**Review of the
Hancock Wind Project
Visual Impact Assessment of Additional
Design Option Comparative Analysis**

Prepared for
Department of Environmental Protection
Augusta, Maine

August 15, 2014

ArcScene Visualization 1b: Lower Lead Mountain Pond: Existing Conditions within 8 miles

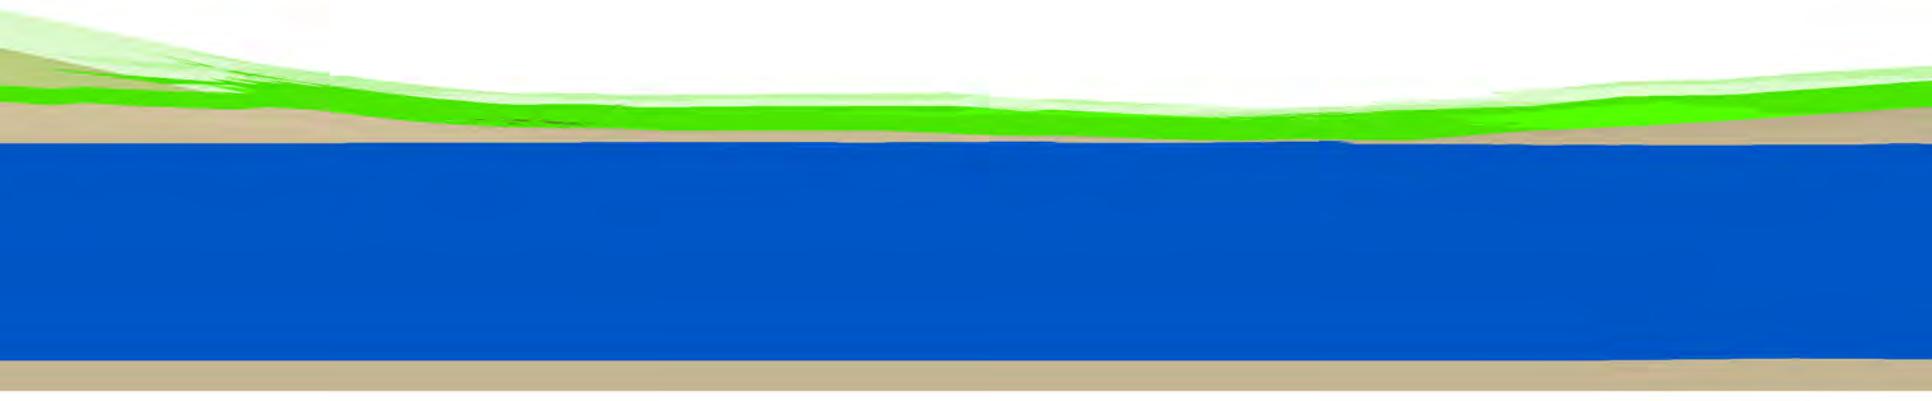
It appears that only three Bull Hill blade tips are visible in the VIA photograph of the existing conditions shows. The existing condition in visualization 1a shows perhaps five Bull Hill turbine hubs and perhaps eight blade tips just visible above the tree line. This illustrates the sensitivity of the analysis; particularly when objects that are so far way and the height of the near-by screening tree line is only approximately known. The Bull Hill turbines are beyond 8 miles from this viewpoint and are not represented in visualization 1b.

ArcScene Visualization 1c: Lower Lead Mountain Pond: Approved Project

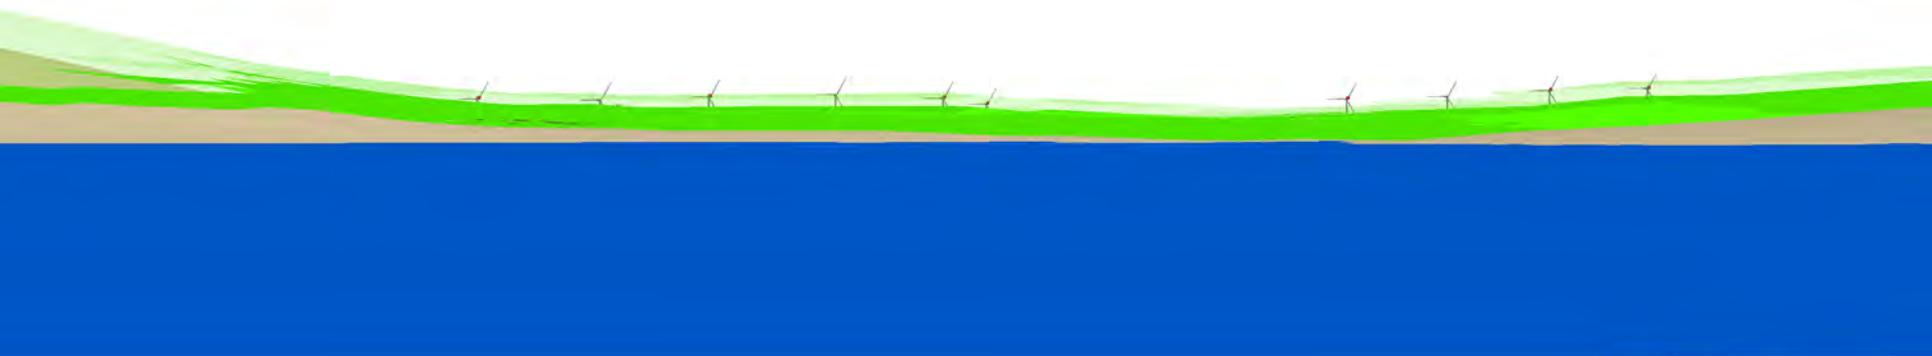
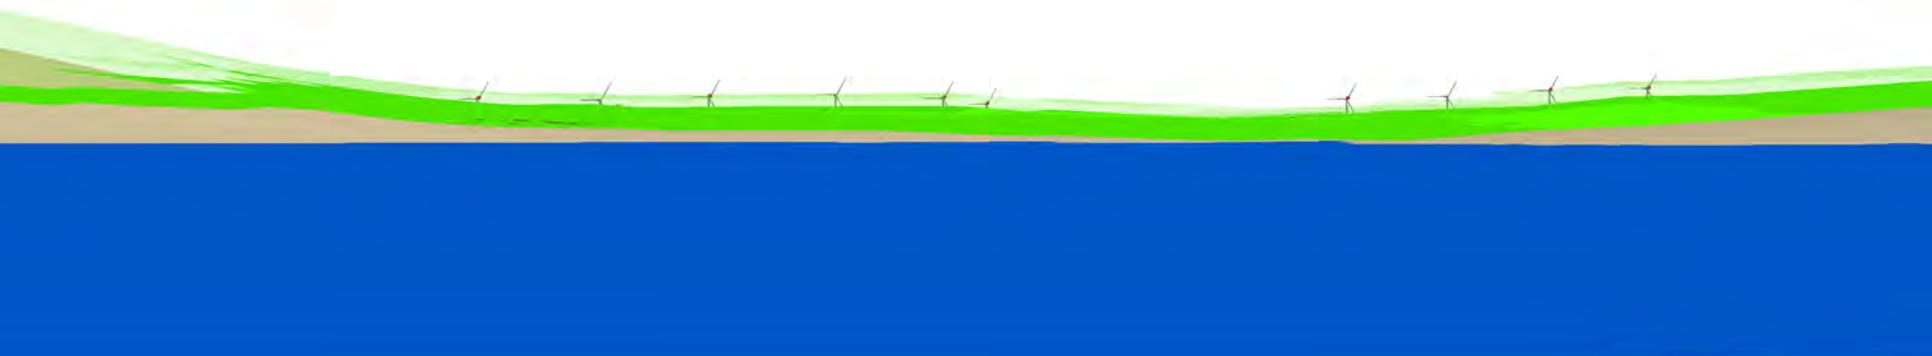
The VIA reports that there is the potential to see 10 blade tips from the approved project on this SRSNS, though I can only identify four in the photosimulation—no hubs are shown. Visualizations 1c and 1d show two hubs just above the tree line and eight addition blade tips. Again, this may be due to under representing the tree line height.

ArcScene Visualization 1g: Lower Lead Mountain Pond: Proposed Amendment

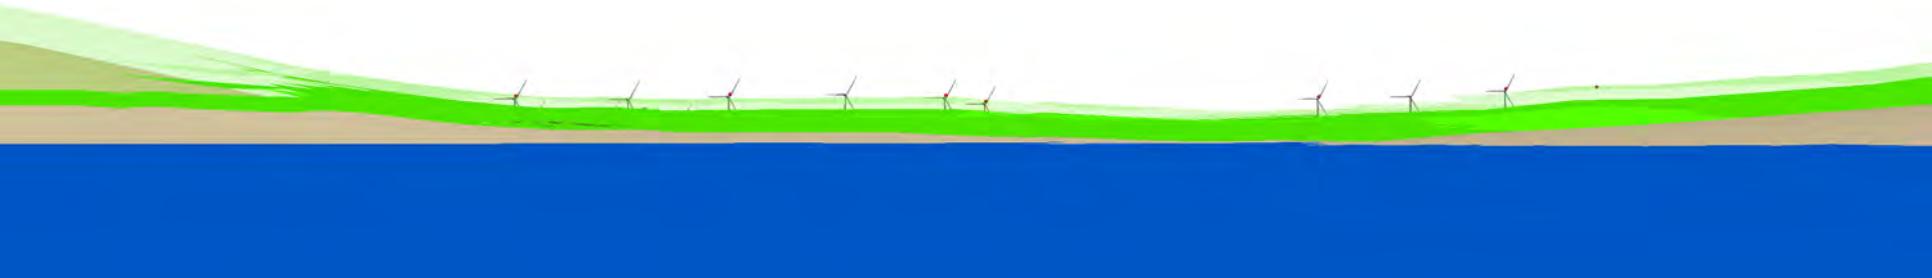
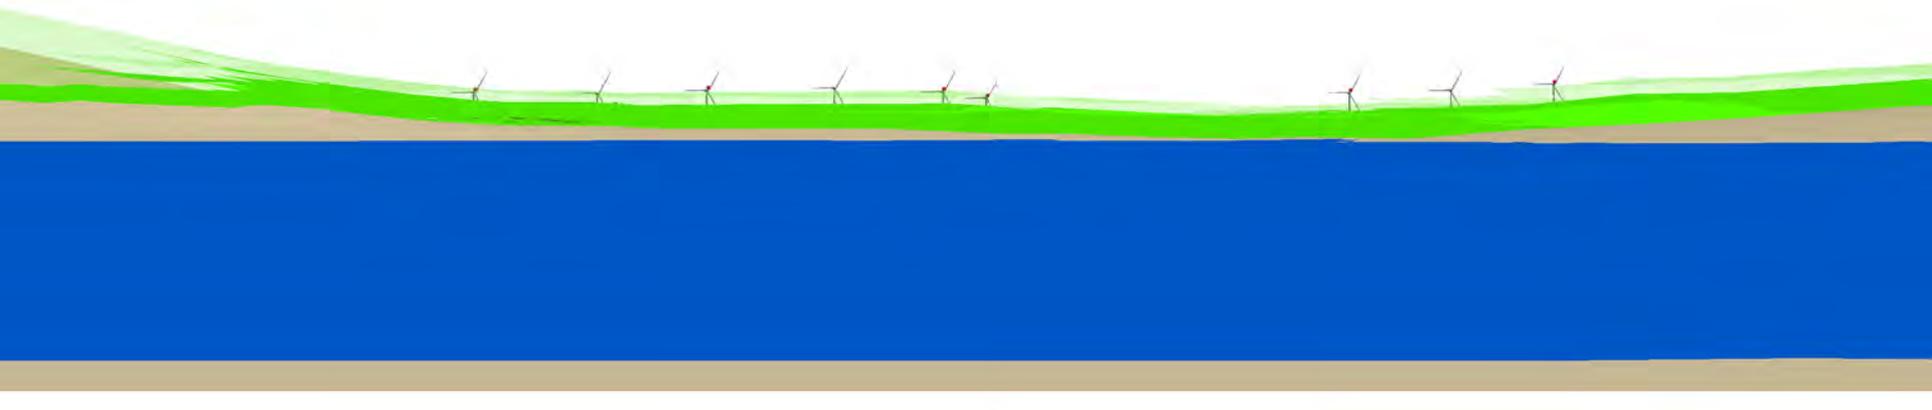
The VIA reports that the photosimulation of the proposed amendment has the potential to show four hubs and five blade tips, though the simulation clearly shows only five blade tips, and no hubs. Visualization 1g and 1h show two hubs clearly above and three or four right at the tree line, plus three or four blade tips. And again, this may be due to under representing the tree line height.

ArcScene Visualization 2a: Upper Lead Mountain Pond: Existing Conditions

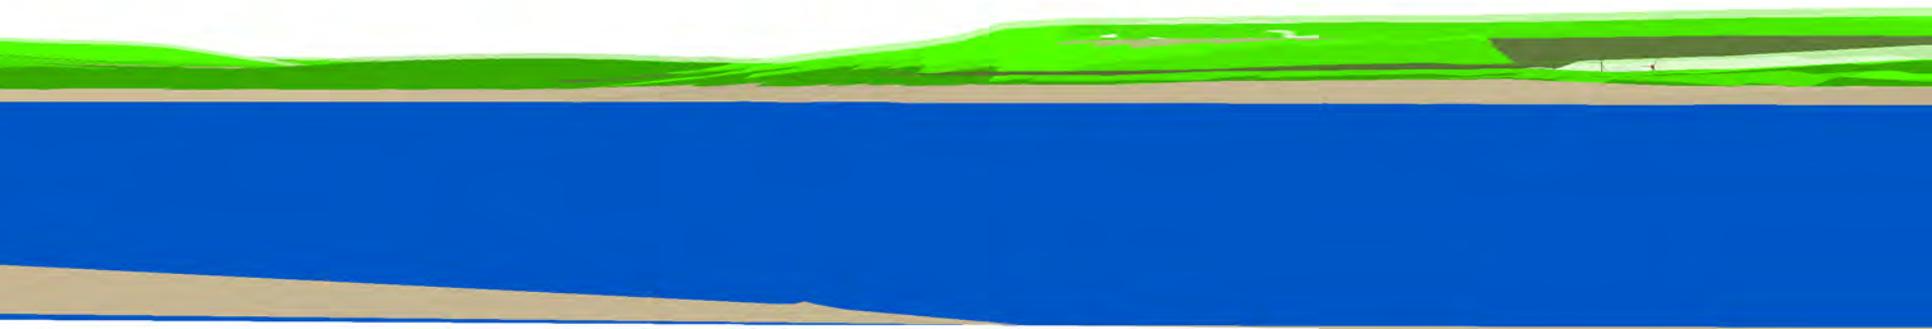
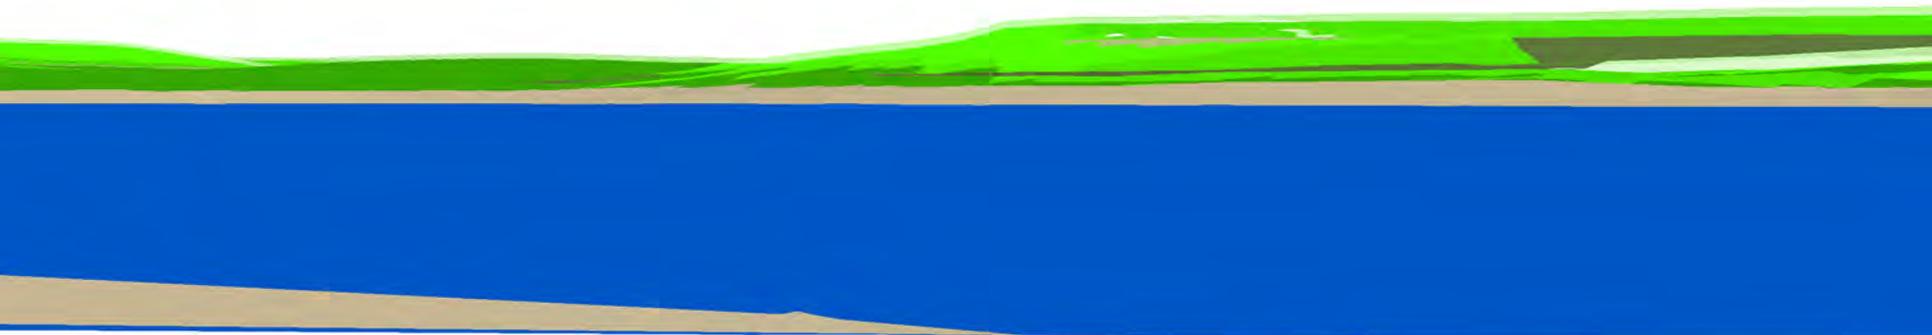
The existing condition photograph in the VIA and visualizations 2a and 2b indicate that the Bull Hill turbines will not be visible from this viewpoint.

ArcScene Visualization 2c: Upper Lead Mountain Pond: Approved Project

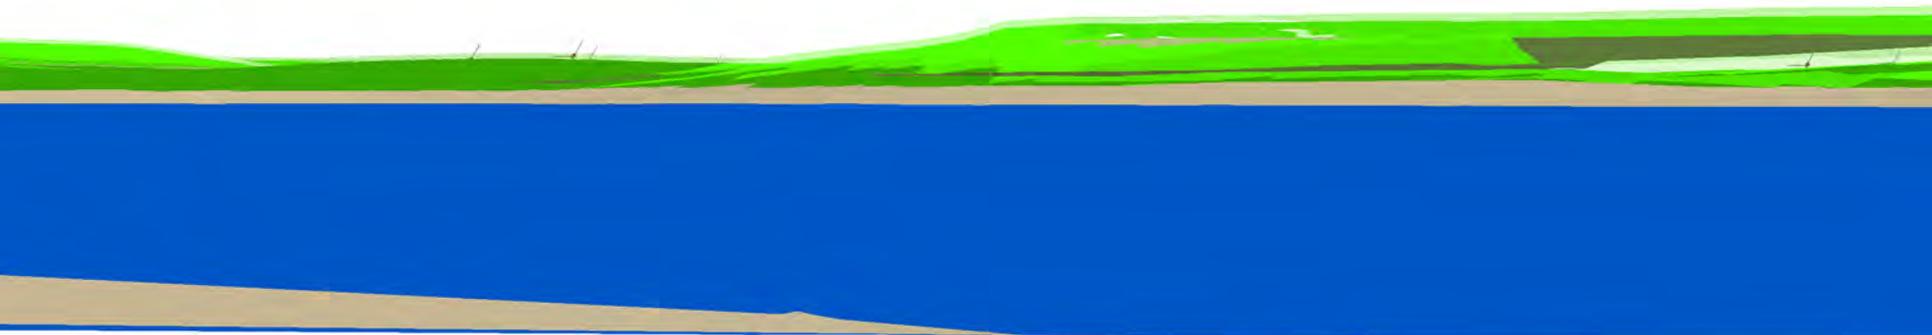
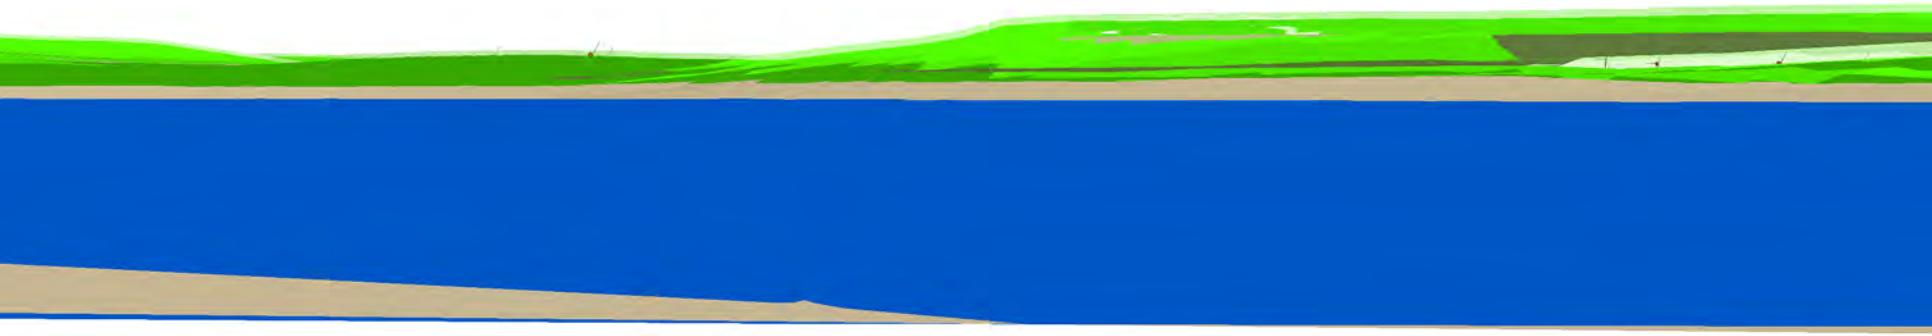
The VIA reports that up to 3 blade tips from the approved project are potentially visible on this SRSNS. The photosimulation of the approved project clearly shows two blade tips, and possibly a third largely obscured by a tree top. Visualizations 2c and 2d show three blade tips.

ArcScene Visualization 2h: Upper Lead Mountain Pond: Proposed Amendment within 8 miles

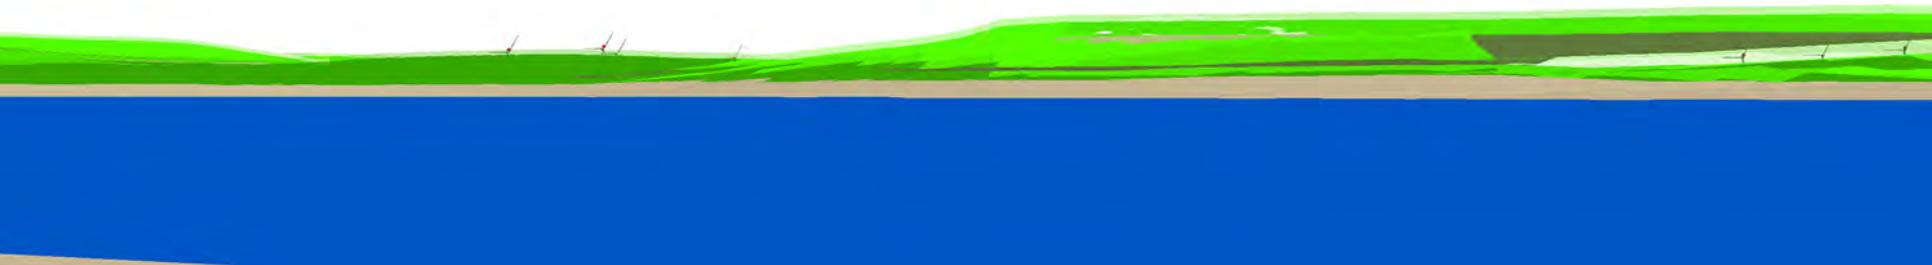
The VIA reports that up to 4 hubs are potentially visible from the proposed amendment; the photosimulation more clearly shows the same three turbine blades visible from this viewpoint for the proposed amendment. Visualizations 2g and 2h show one hub just above the tree line and three blades.
